NISSAN DIESEL AMERICA, INC. RECALL BULLETIN

DATE: AUGUST 30, 1999
MODEL YEAR: 1998 ~ 2000
MODELS AFFECTED: UD1200/UD1400
BULLETIN #: SC - 209

VOLUNTARY SAFETY RECALL CAMPAIGN #99V - 209:
1998 ~ 2000 MODEL YEAR UD1200 AND UD1400 FRONT STEER AXLE TIRE REPLACEMENT

D.O.T. SERIAL NUMBER EXAMPLE

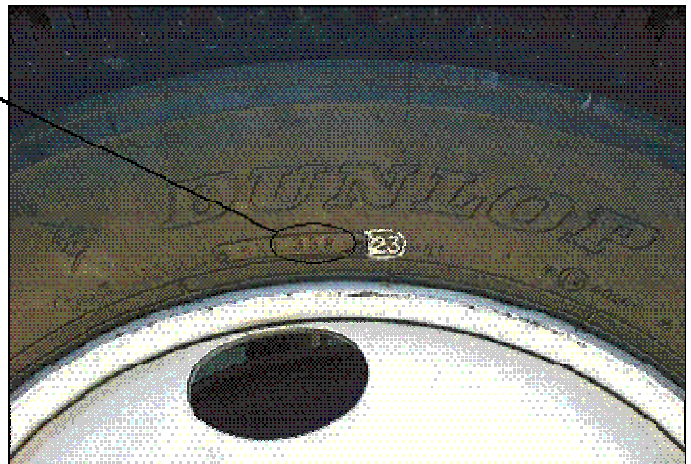
Dunlop Tire Corp. has determined that affected SP LT5 tires manufactured within a certain D.O.T. serial number range were installed on some of the listed vehicles. A D.O.T. serial number is a 10-digit code stamped into one side of the lower sidewall. The last three digits indicate the week and the year that the tire was produced, as illustrated below.

AFFECTED TIRE D.O.T. SERIAL NUMBER RANGES:

UD1200

U2BA7KL308 ~ 129

UD1400

U2BAWKL198 ~ 129

Inspect the front steer axle tire D.O.T. serial numbers of listed vehicles. If one or both front steer axle tire D.O.T. serial numbers on a listed vehicle fall within the ranges shown above, proceed with tire replacement according to the following instructions. If not, place a mark in Box 01 (Inspected - No corrections necessary) of the "AUTHORIZATION FOR RECALL SERVICE" card and return it to NDA.

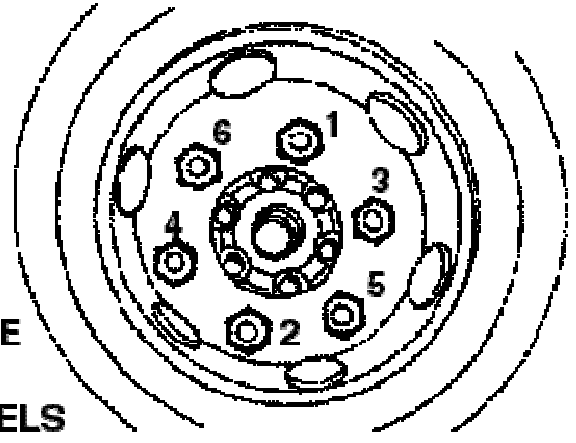
8. Tighten the wheel nuts incrementally in the sequence shown below to reach the specified torque.

NOTE
WHEEL NUT
TORQUES ARE
DIFFERENT
BETWEEN MODELS

UD1200 WHEEL NUT TORQUE
 325 - 398 ft-lbs
 (441 - 539 N-m) (45 - 55 kg-m)

UD1400 WHEEL NUT TORQUE
 268 - 311 ft-lbs
 (363 - 422 N-m) (37 - 43 kg-m)
